Erratum

The 'Dibble' – A digital mode interface box, with an introduction to PSK31

Figure 4: Schematic diagram of the 'Dibble'.

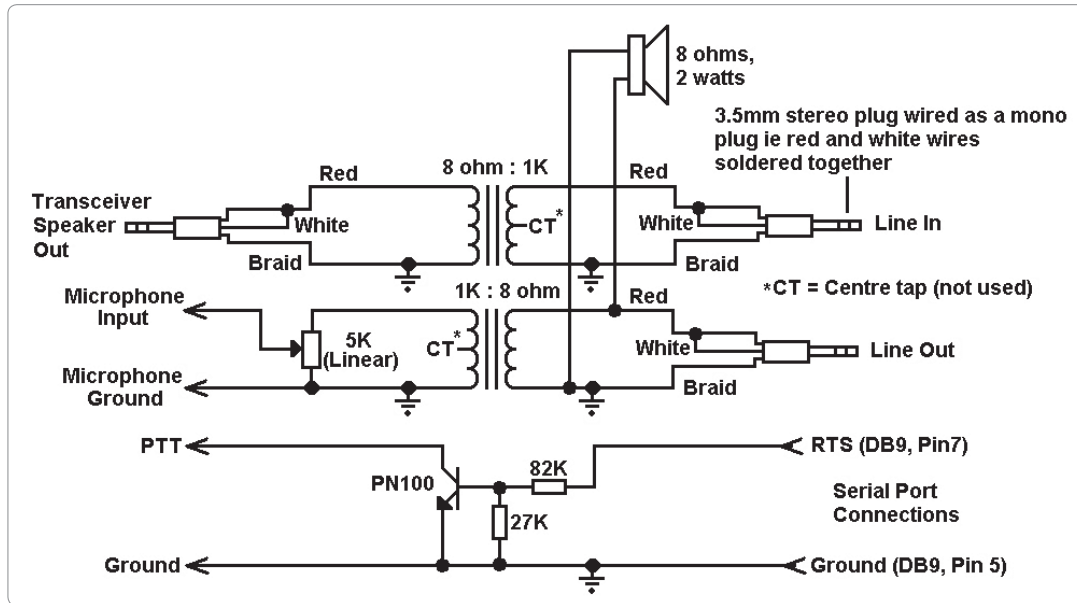
The author of this article, published in the January/February 2012 issue of AR, Ross Fraser VK2WN advises that the original Figure 4 had a couple of mistakes and that the replacement Figure 4 has corrected those errors – being the placement of a speaker in the line out circuit and the addition of an earth in the PTT section.
